To: T13 Technical Committee  
From: Rob Elliott, HP (elliott@hp.com)  
Date: 3 November 2009  
Subject: e09127r1 EDD-4 Hybrid MBR support

**Figure B.1 — GPT disk layout with hybrid MBR partition records example**

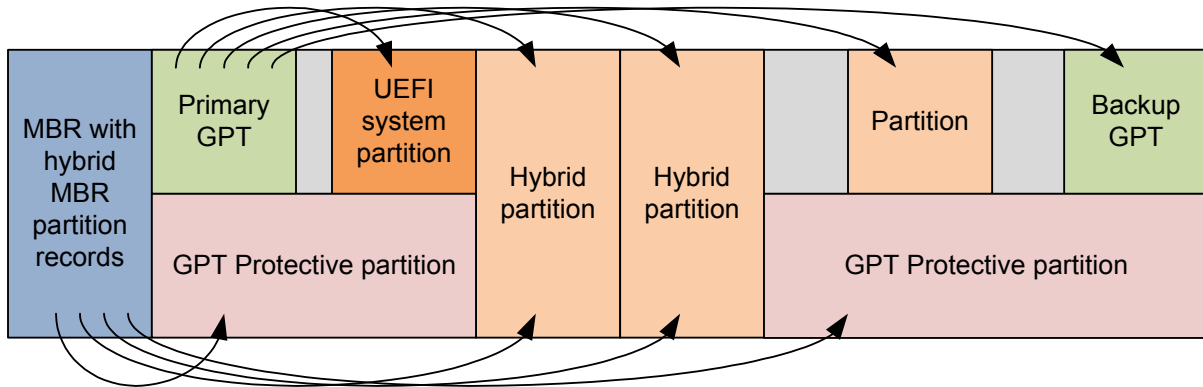
Hybrid MBR partition records are a technique that has been used to enable booting legacy BIOS compatible OSES on systems supporting both UEFI and legacy BIOS system firmware. With this technique, the GPT disk layout is used, but the MBR does not comply with the protective MBR requirements (see UEFI-2.3).

- a) legacy MBR boot code; and
- b) one partition record protecting the Primary GPT and the UEFI system partition;
- c) one partition record pointing to a hybrid partition (pointed to by both MBR and GPT partition tables)
- d) additional partition records pointing to additional hybrid partitions, or protecting the remaining capacity of the disk.

Because this technique does not comply with the protective MBR requirements, it might interfere with the proper behavior of UEFI OSES and UEFI system firmware. This technique requires partitioning tools to keep the MBR and GPT synchronized; running a tool that does not understand the technique might result in overlapping partitions and lost data.

**Figure C.1 — GPT disk layout with hybrid MBR boot code example**

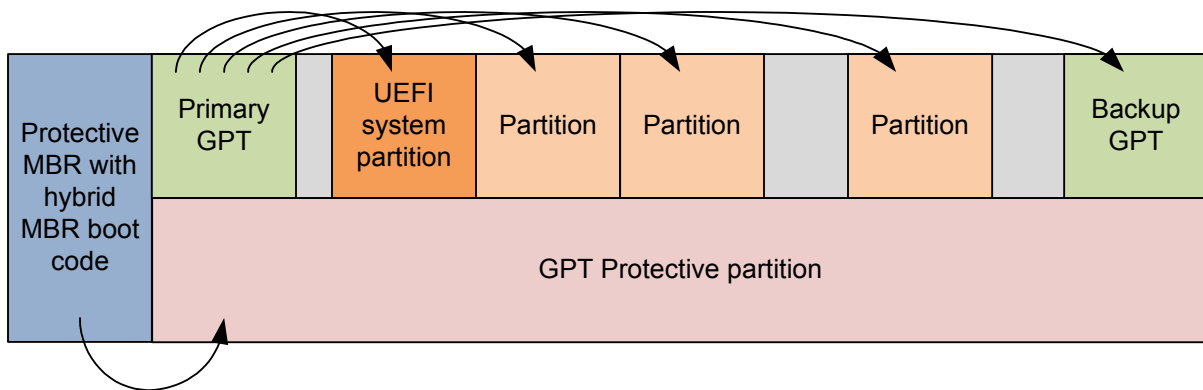
Annex A describes how MBR boot code may be constructed to support a GPT disk layout in a legacy BIOS system; this is called hybrid MBR boot code. This annex describes the changes to the Protective MBR format defined in UEFI-2.3 to implement this approach.

The GPT disk layout includes one GPT partition with the Legacy BIOS Bootable bit set to one in the Attributes field.

The Protective MBR is modified as shown in table C.1 to include hybrid MBR boot code.
